BNL CCWF II
Addendum 2
Revised Drawings

JOB NO.	SHEET NO.	REVISION	DATE	DWN.	APP'D.	CK
		A Addendum #2	4/14/09

JOB TITLE: CENTRAL CHILLED WATER FACILITY PHASE II		DWG. TITLE: SITE PLAN	
R.R.GPP,J.M., HEM	DATE	ACCT. NO.	SHEET OF
SCALE 1"=20'-0"	DWN. BY SSK / REV'D BY XX	JOB NO. 11705	DWG. NO. CE-03
ESHQ RISK LEVEL	APP'D. BY	BLDG. NO. 600	
PATH:

402B ENLARGED PLAN SITE SUBSTATIONS 600A & 600B
ES-101 1/4" = 1'-0"

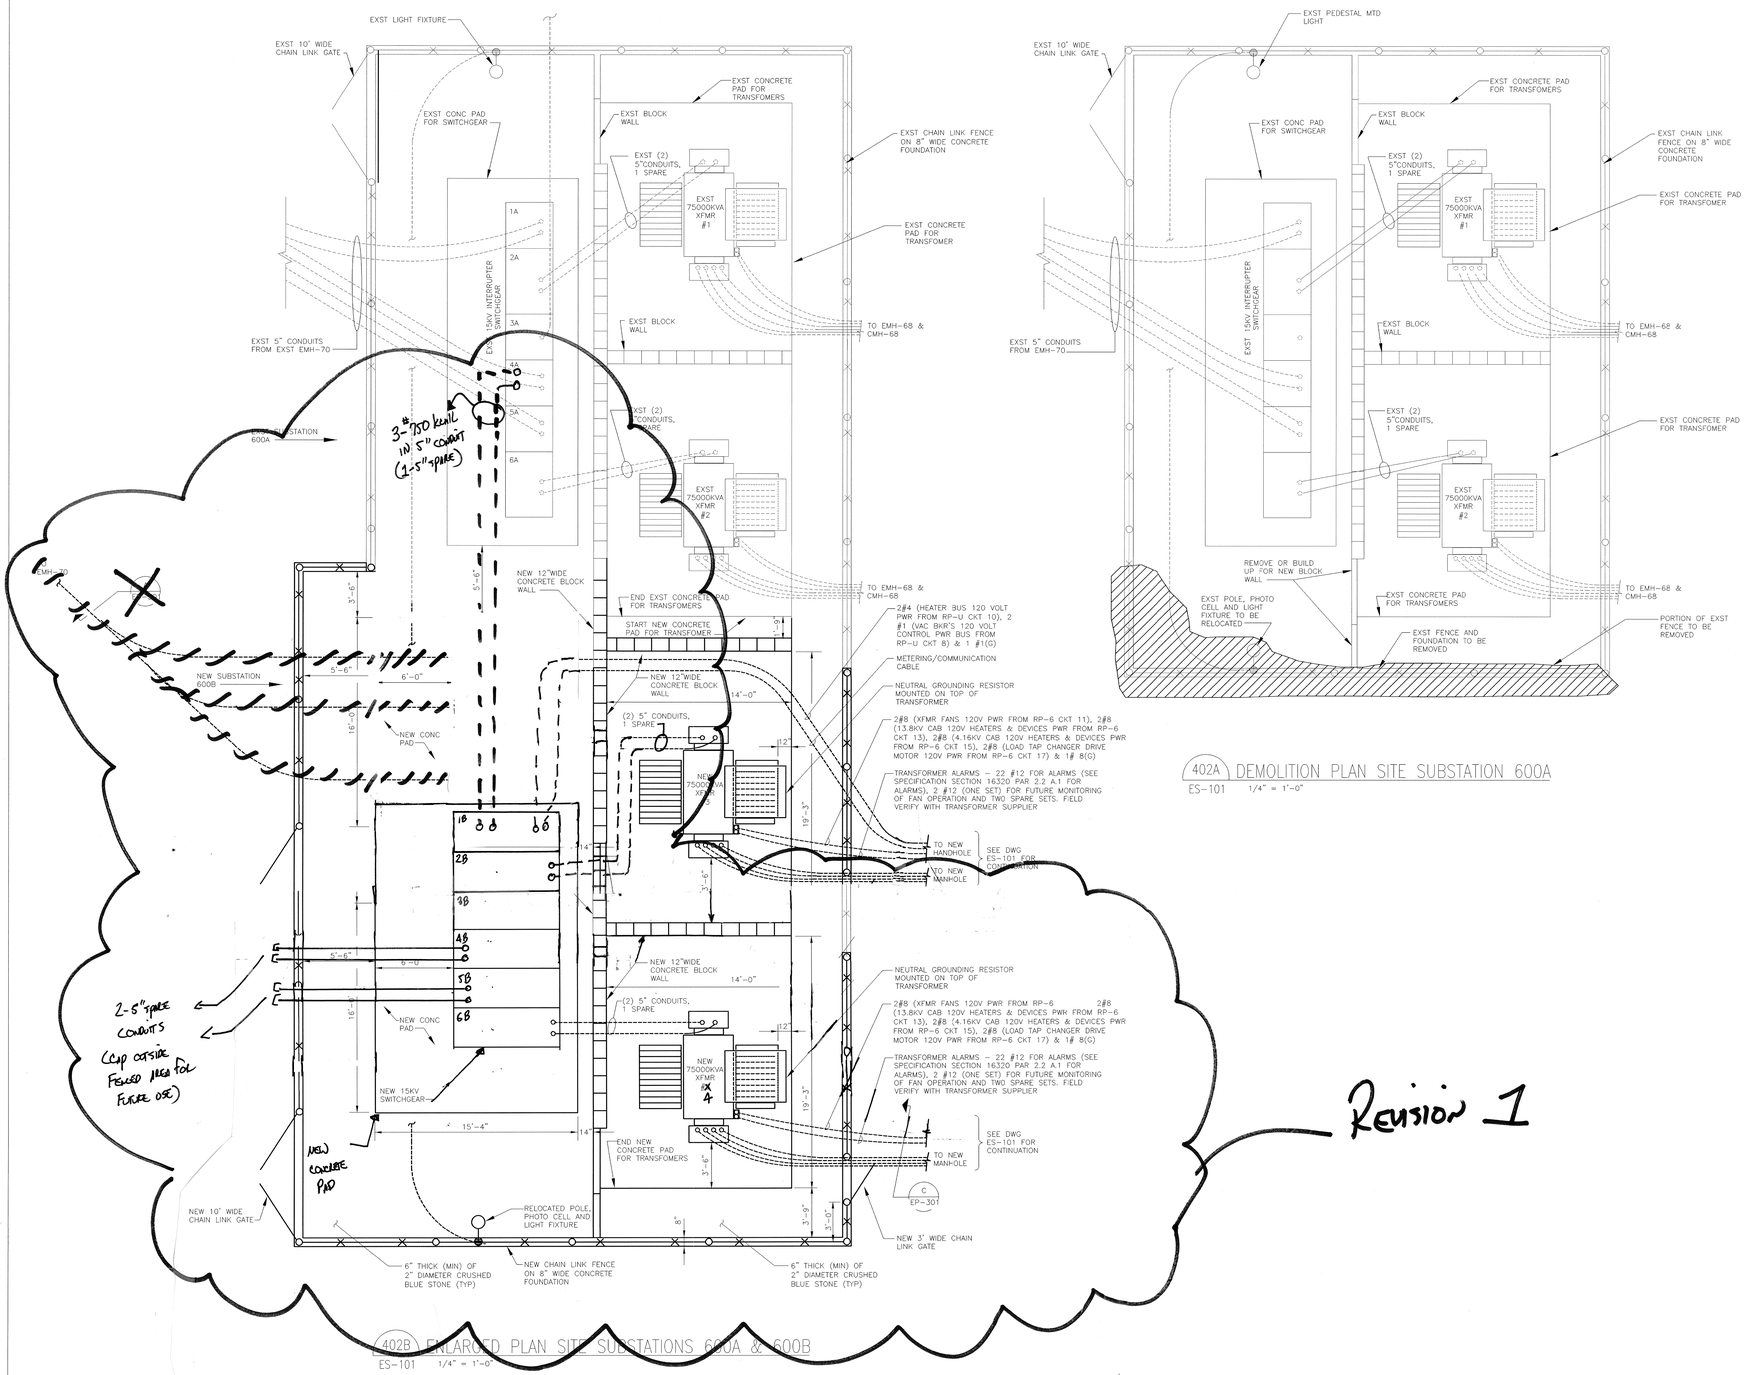
Revision 1

403A ENLARGED PLAN SITE GROUNDING
ES-101 1/4" = 1'-0"

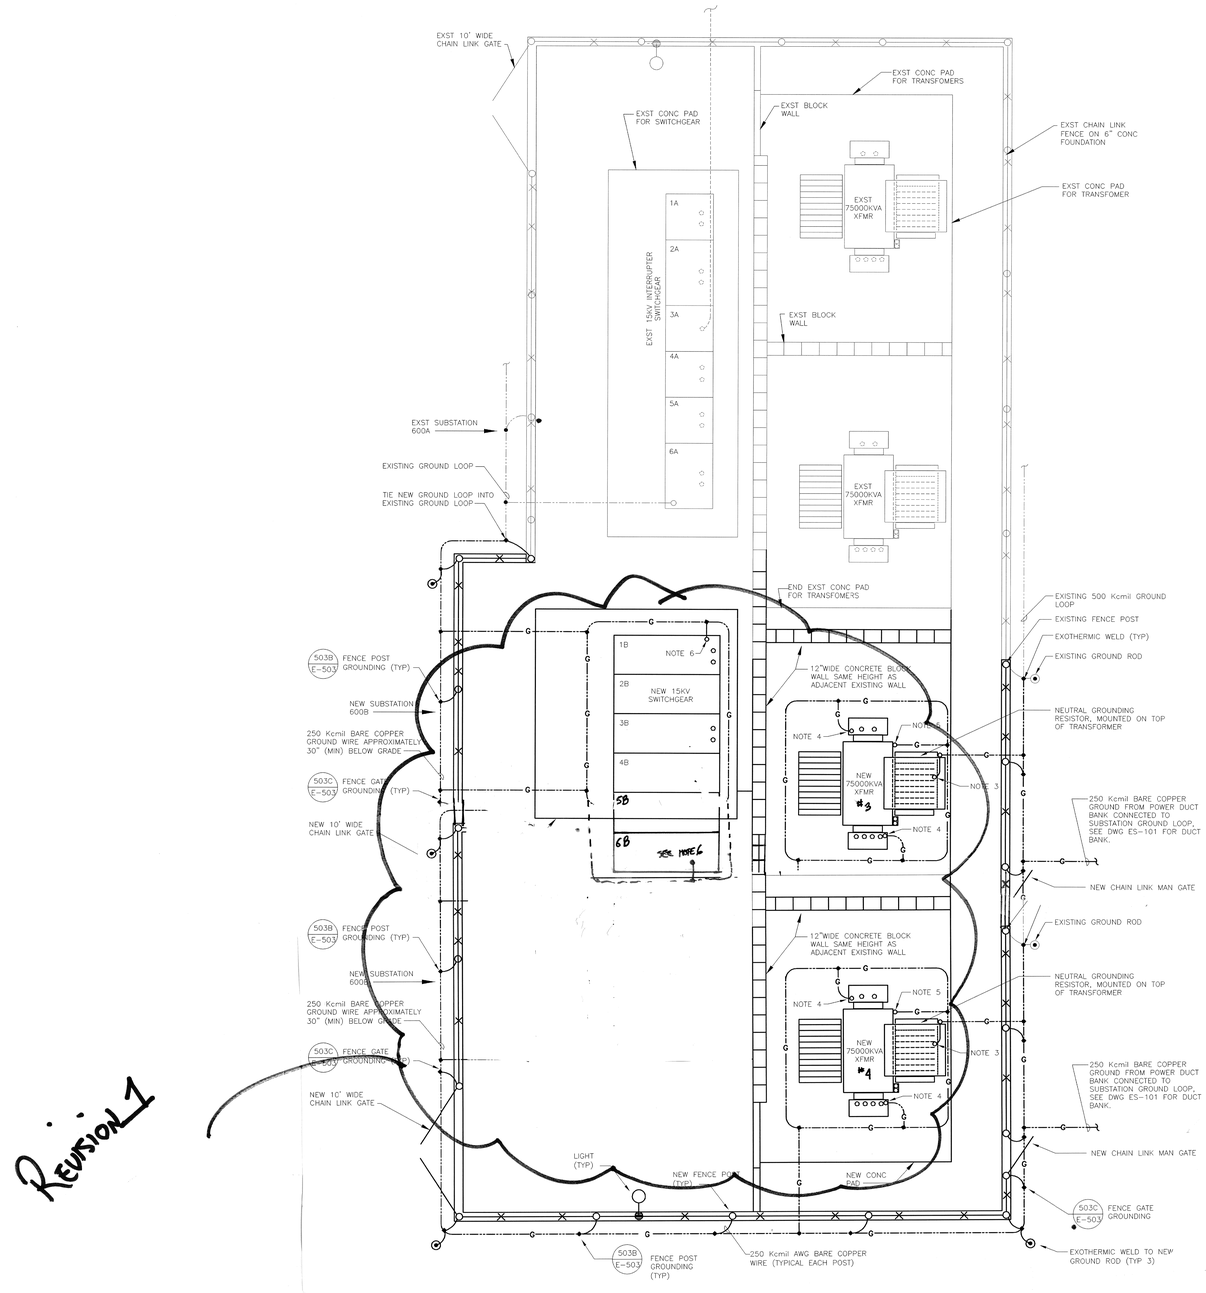
REVISION 1

1. ALL GROUND WIRES TO SHALL BE 250 Kcmil BARE COPPER U.O.N.
2. NOT USED.
3. GROUND RESISTOR ELEMENT TO GROUND LOOP. RUN 250 Kcmil BARE COPPER GROUND WIRE FROM GROUND RESISTOR TO GROUND LOOP SIMILAR TO EXISTING TRANFORMER.
4. BOLTED CONNECTION TO GROUND BAR IN AIR TERMINAL BOX.
5. GROUND TRANSFORMER RAIL.
6. 250 Kcmil BARE COPPER GROUND WIRE TO SWITCHGEAR GROUND BUS FROM GROUND LOOP.
